LEGACY CHURCH - GREEN MOUNTAIN FALLS, CO DEVELOPMENT PLAN

COVER SHEET
SHEET 1 OF 13

Site Plan_v2_redlines.pdf Markup Summary

REV: 9/17/19
UTILITY SHEET
SHEET 4 OF 13

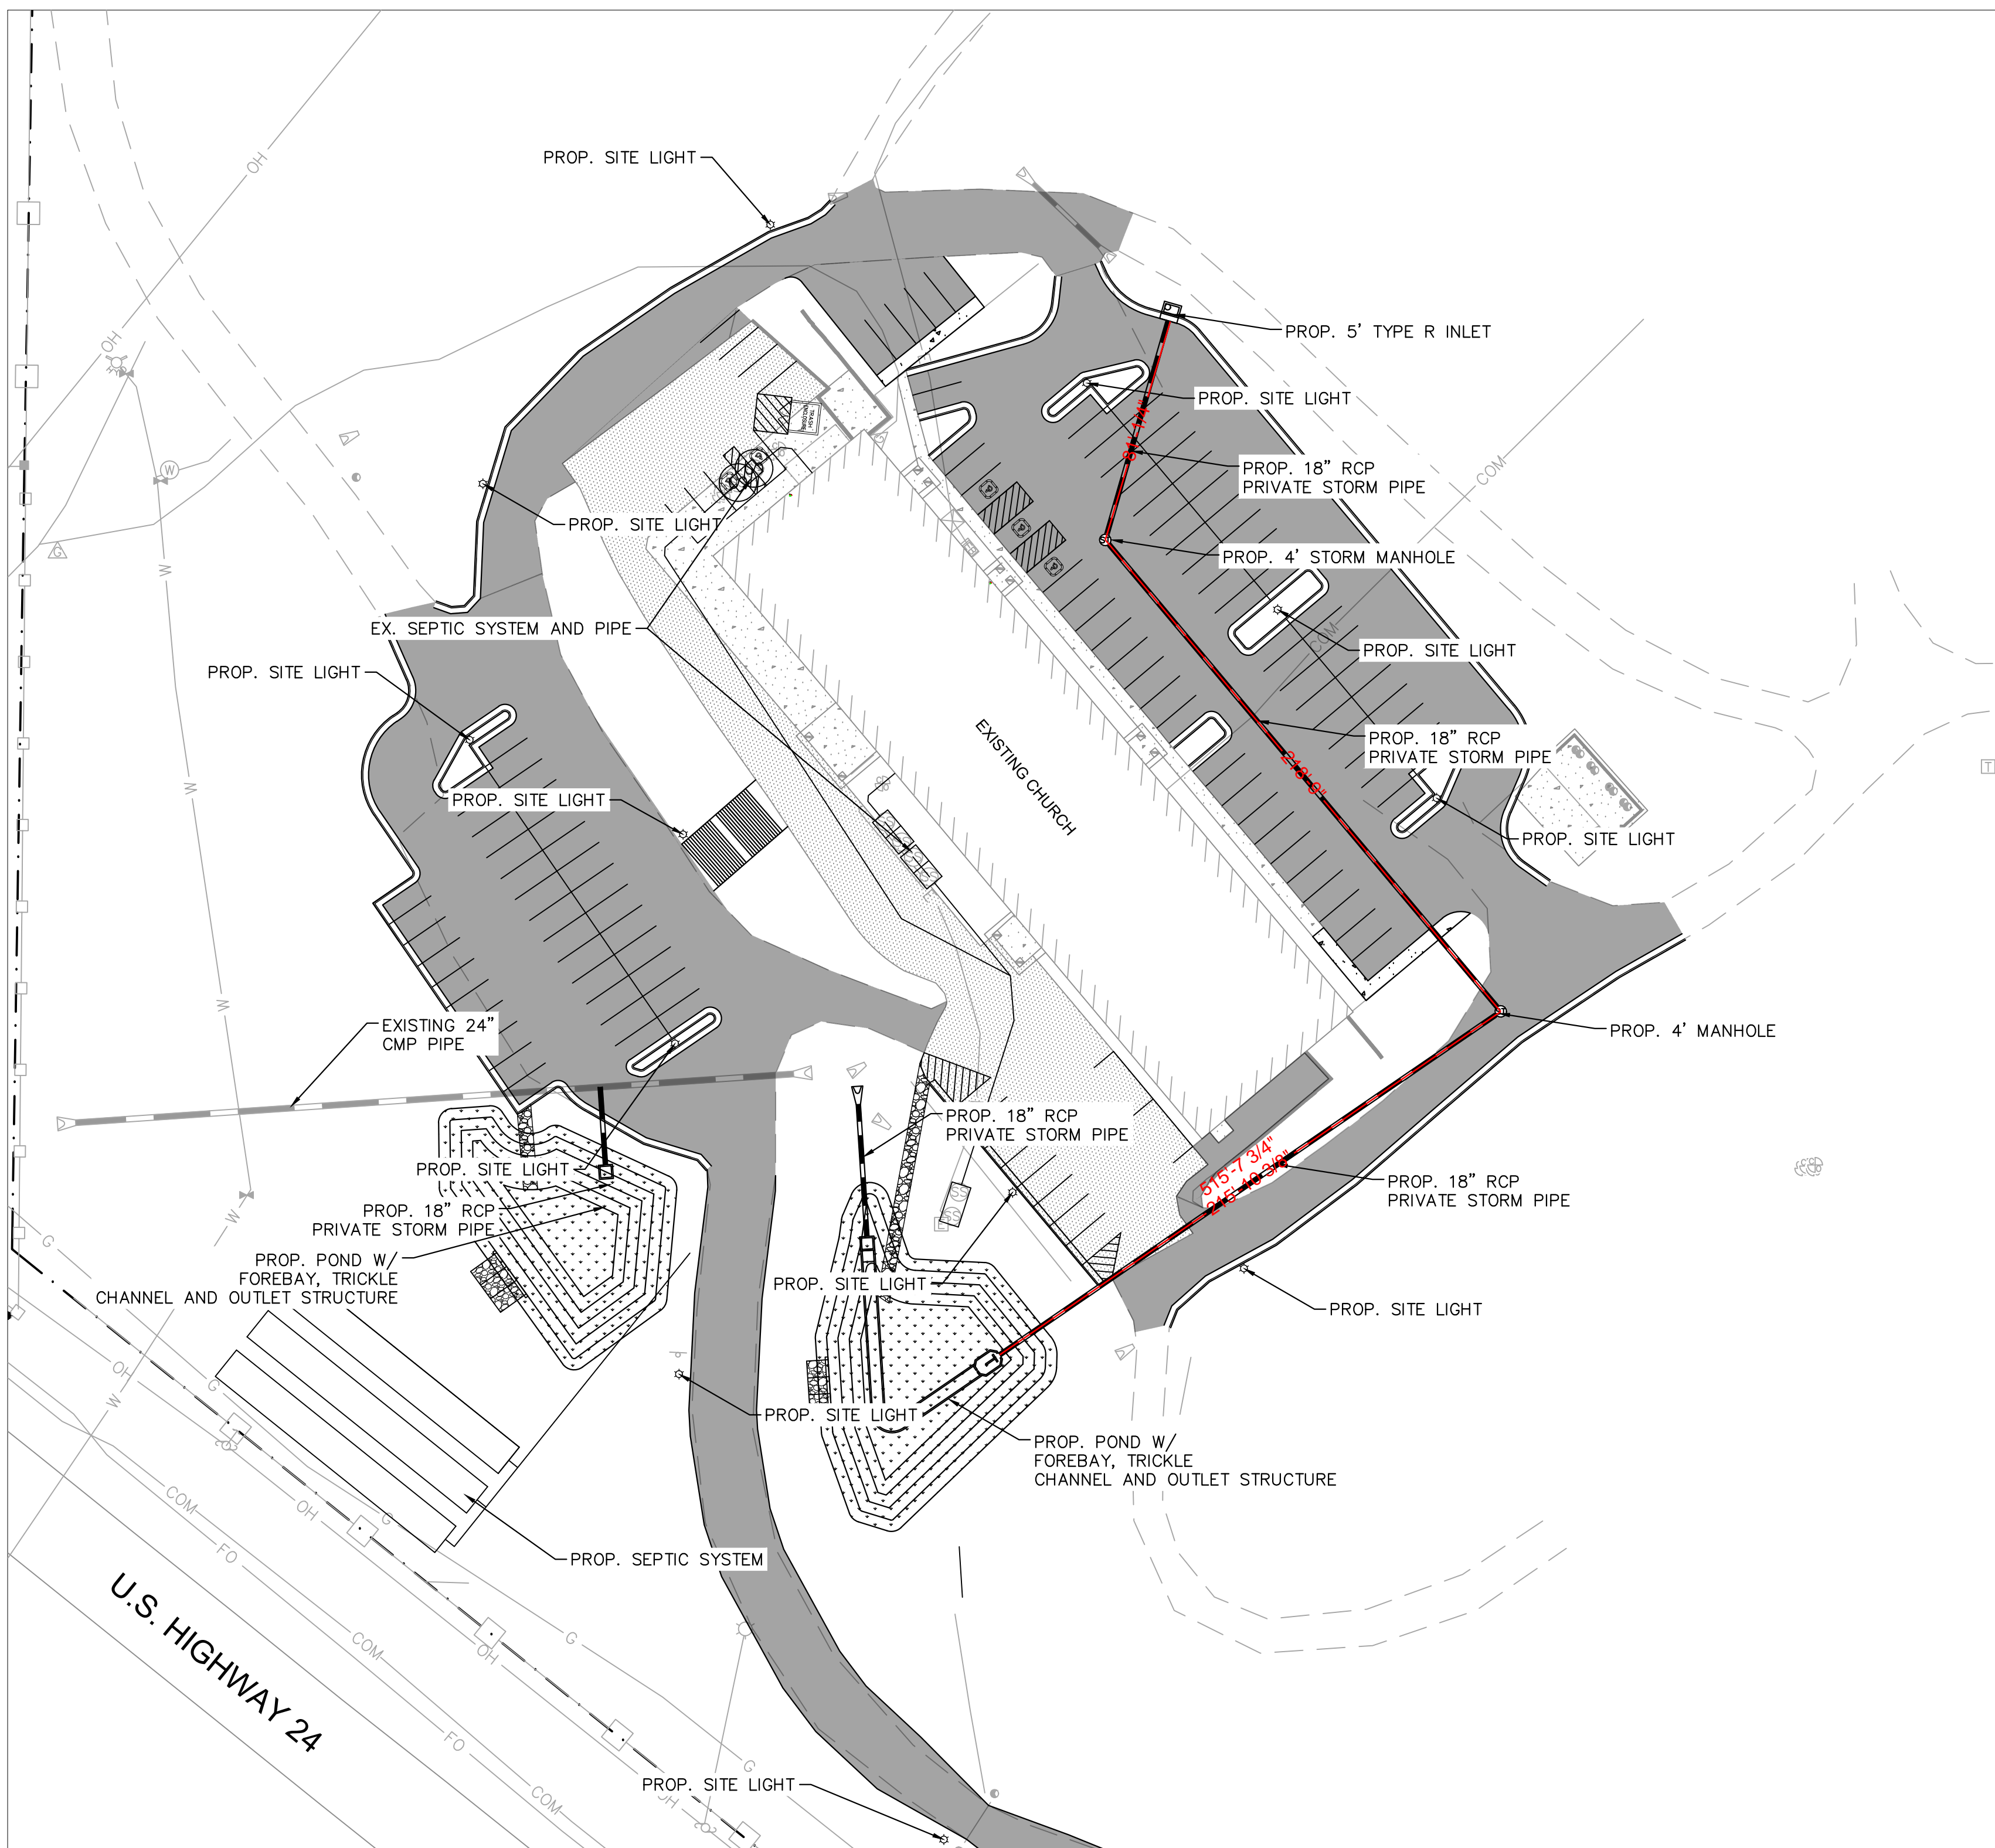
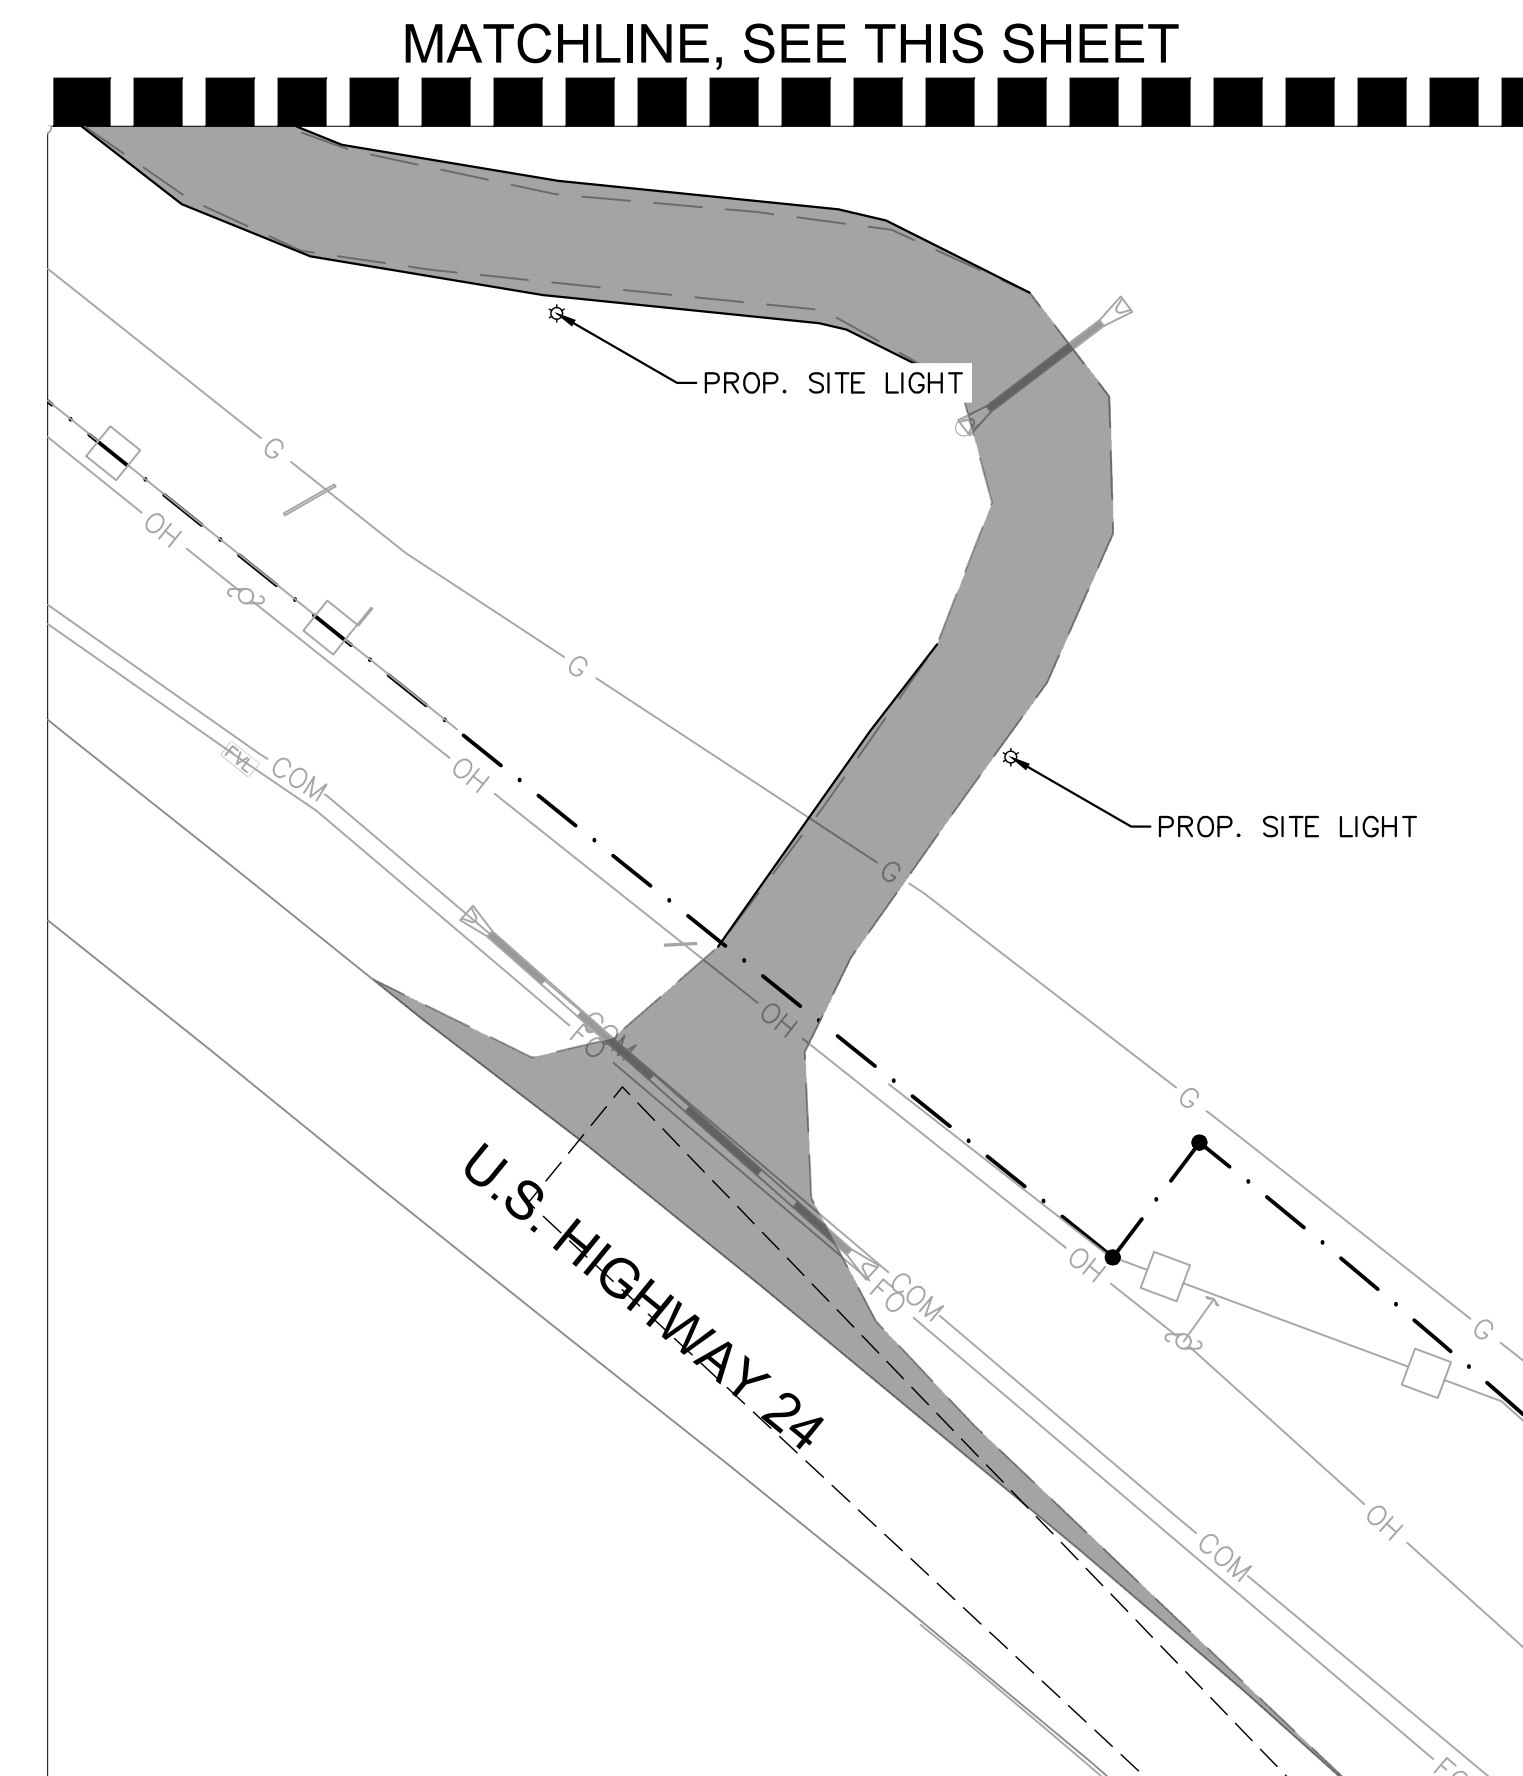
Review 1 comment:
 Parking information does not match what is shown on the previous page. Revise accordingly.

Review 2: Unresolved. The building capacity also does not match the previous page. Please revise so that all the information is matching.

Review 1 comment:
Parking information does not match what is shown on the previous page. Revise accordingly.

Review 2: Unresolved. The building capacity also does not match the previous page. Please revise so that all the information is matching.
